RESOLUTION 1276

A RESOLUTION OF THE CITY COUNCIL OF THE CITY OF GIG HARBOR, WASHINGTON, AMENDING THE WASTEWATER COMPREHENSIVE PLAN BY REVISING THE SEWER COLLECTION BASIN BOUNDARY BETWEEN SEWER COLLECTION BASINS #18 AND #3.

EXHIBIT A

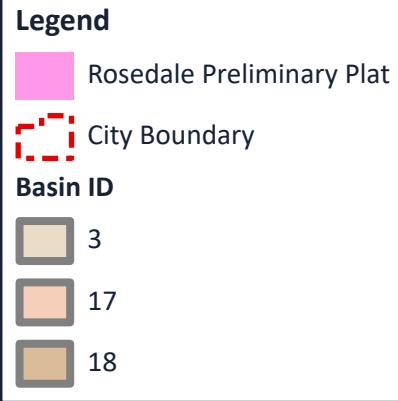
Section 1. Appendix B of the Wastewater Comprehensive Plan shall be amended to reflect the revisions to the Wastewater Basin Map as provided in the attached Exhibit A.

AREA PROPOSED
TO BE MOVED FROM
BASIN 18 TO BASIN 3

PROPOSED BASIN
18/3 LINE

EXISTING BASIN
18/3 LINE

OPTION #3
